Reference: **Student Accommodation Project
183 MACQUARIE STREET, PARRAMATTA NSW**

ACCESS REPORT – LEC SUBMISSION

STUDENT ACCOMODATION 183 MACQUARIE STREET PARRAMATTA NSW 2150

Document Type: Access Report - LEC Submission
Report Number: IAC-1589

Figure 14 – Location of circulation stairs at ground floor level.

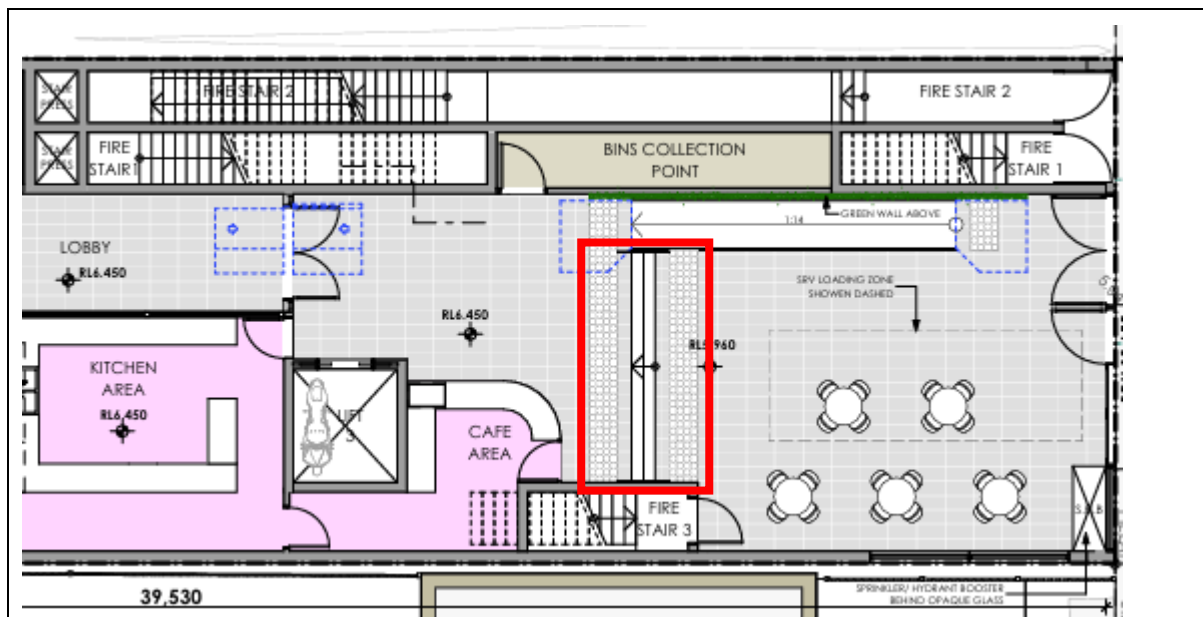
The circulation stairs will need to comply with the provisions noted at Clause 11 and 12 of AS1428.1:2009.

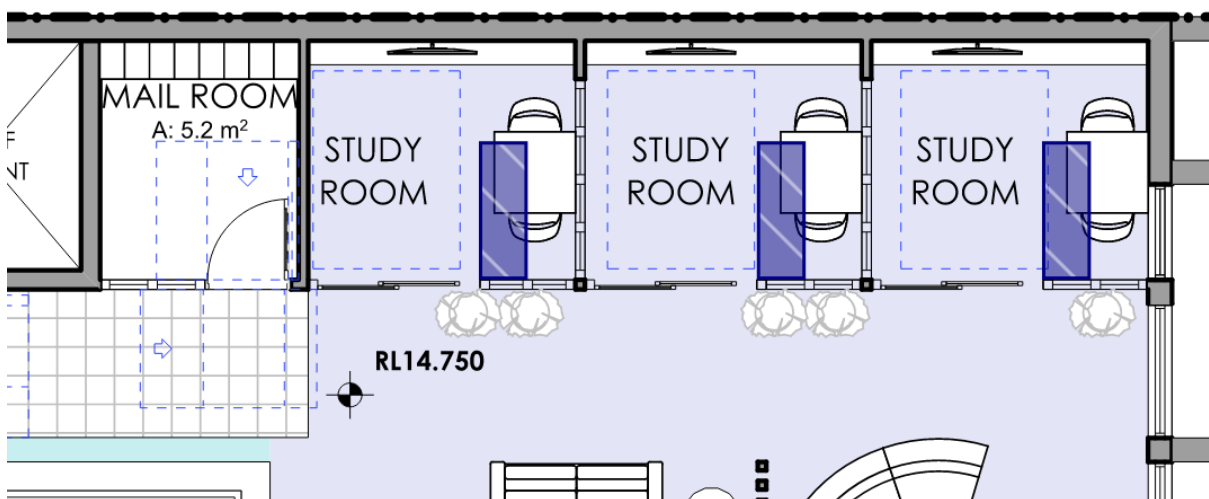
The door details to the 3 Study Rooms will need to be revised to achieve the required 530mm latchside clearance. Alternatively, a Performance Based Design Solution will need to be prepared to address circulation to and within these study areas. The hatch on the extract from the plan indicate the required 530mm latchside clearance associated with sliding doors.

3.10.5. Circulation at Doorways – A performance based design solution will need to be prepared to address circulation to and within the Study rooms. This performance solution will be required for the issue of the Construction Certificate.
